Access Compliance Report

Public Rights-of-Way

(Curb Ramps)

Intersection ID: 45514	Main Street: MEADOW_BOTTOM_RD	Cross Street: COTTON_PRESS_RD	Location:	N
ADA ID: C6FE1F297660	Ramp Type: PerpDiag	Initial Pass/Fail: Fail	Overall Compliance: No	Severity Score: 21.25
Codes/Mitigation Info/Possible Solution		Field Measurements/Component Compliance

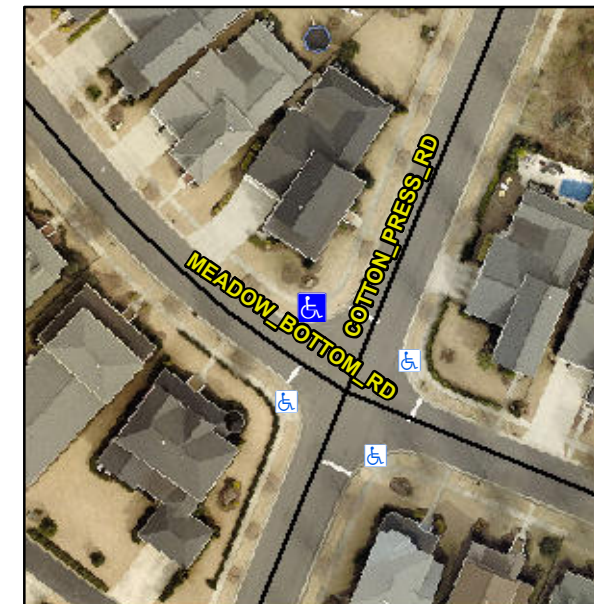
Not Found, R304.5.1, R304.2.2

Compliance	Description	Data	Compliance	Description	Data
N/A	Ramp Length (in)	72.0	No	Ramp Slope (%)	8.6
No	Ramp Width (in)	37.0	Yes	Ramp XSlope (%)	1.3
N/A	Flare Type LT	N/A	N/A	Flare Type RT	N/A
N/A	Flare Slope LT (%)	N/A	N/A	Flare Slope RT (%)	N/A
N/A	Flare Traversable LT?	N/A	N/A	Flare Traversable RT?	N/A
N/A	Landing Length (in)	N/A	N/A	DWS Provided?	N/A
N/A	Landing Width (in)	N/A	N/A	DWS Contrast?	N/A
N/A	Landing Slope (%)	N/A	N/A	DWS Length (in)	N/A
N/A	Landing X Slope (%)	N/A	N/A	DWS Full Width?	N/A
N/A	Landing Curb? (Y/N)	N/A	N/A	DWS Offset (in)	N/A
N/A	Shared Landing?	N/A			
N/A	Gutter Ponding?	N/A	N/A	Gutter Slope (%)	N/A
N/A	Gutter Lip Ht (in)	N/A	N/A	Gutter X Slope (%)	N/A
N/A	Painted X Walk1?	No	N/A	Painted X Walk2?	No
	X Walk 1 Direction	To SW		X Walk 2 Direction	To SE
N/A	X Walk 1 Width (in)	N/A	N/A	X Walk 2 Width (in)	N/A
	X Walk 1 Slope (%)	2.5		X Walk 2 Slope (%)	0.1
	X Walk 1 X Slope (%)	0.8		X Walk 2 X Slope (%)	1.1

Remove & Replace Curb Ramp With Two New Directional Ramps or Equivalent.
